KENYA ELECTRICITY GENERATING COMPANY PLC

KGN-HYD-034-2024

TENDER FOR A SUBMERSIBLE DEWATERING PUMP FOR KAMBURU POWER STATION.

**CLARIFICATION NO.2**

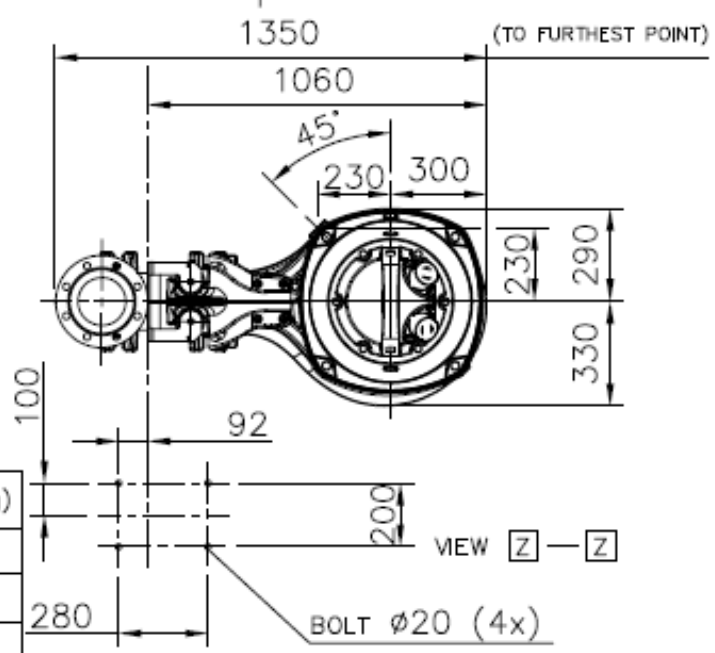
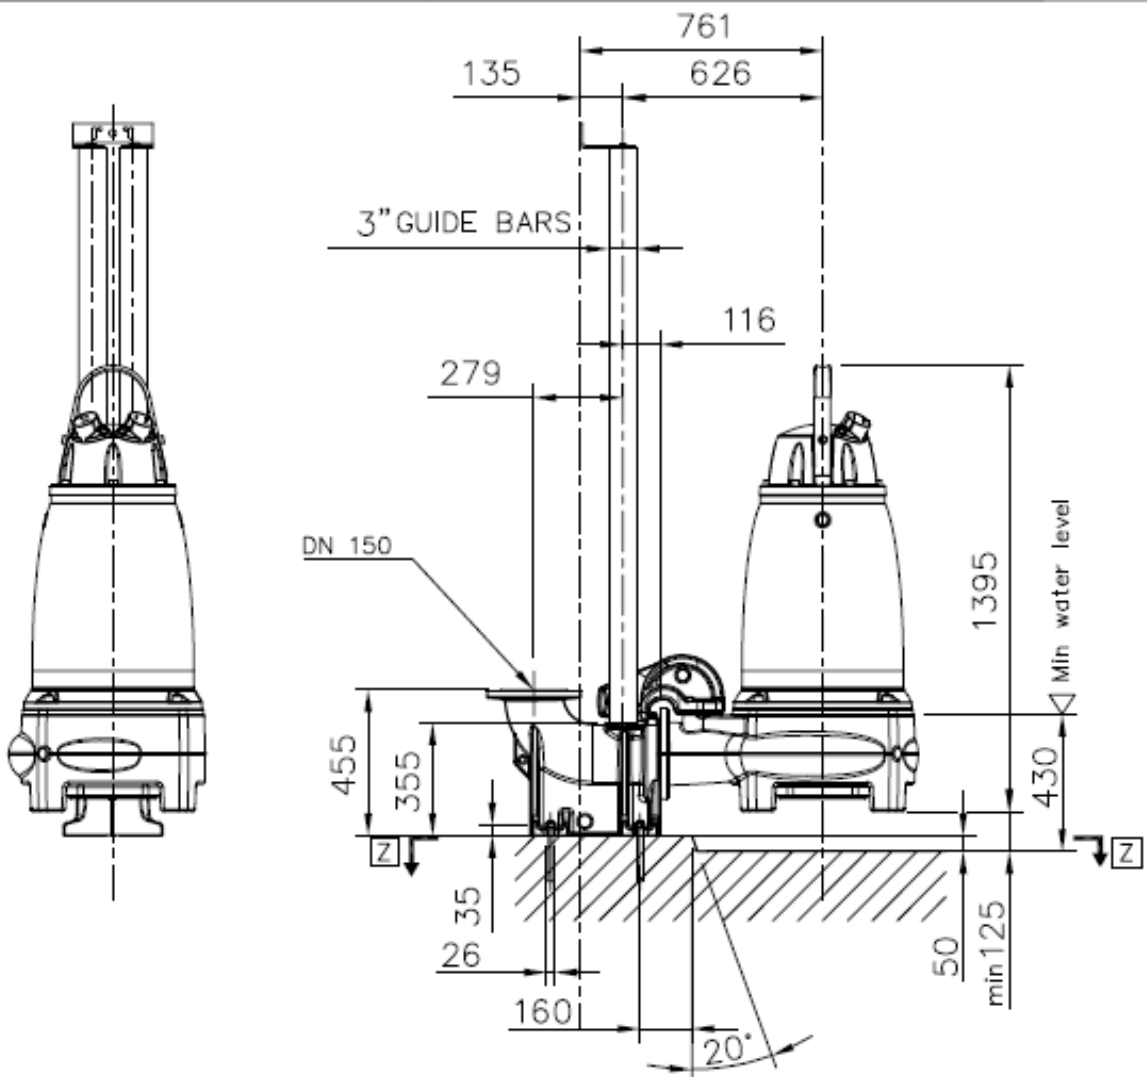
Bidder's Clarification	KenGen's Response
1. Could you kindly share a photo of the nameplate or tag plate of the existing pump to assist us in pump selection.

<p>6. In the bid documents in page 59 it states that The pump shall be of similar design to the existing one you have and is to be replaced, thereby enabling it to be easily assembled and mounted in the existing stool arrangement for existing pump as per the attached sketches. There is no any attached sketches. Hence requesting for pictures for the existing pump please.</p>	<p>The existing design is as per the appended drawing.</p>

Weight (kg)
Pump with cooling jacket	850
Pump without cooling jacket	780
Discharge connection	91
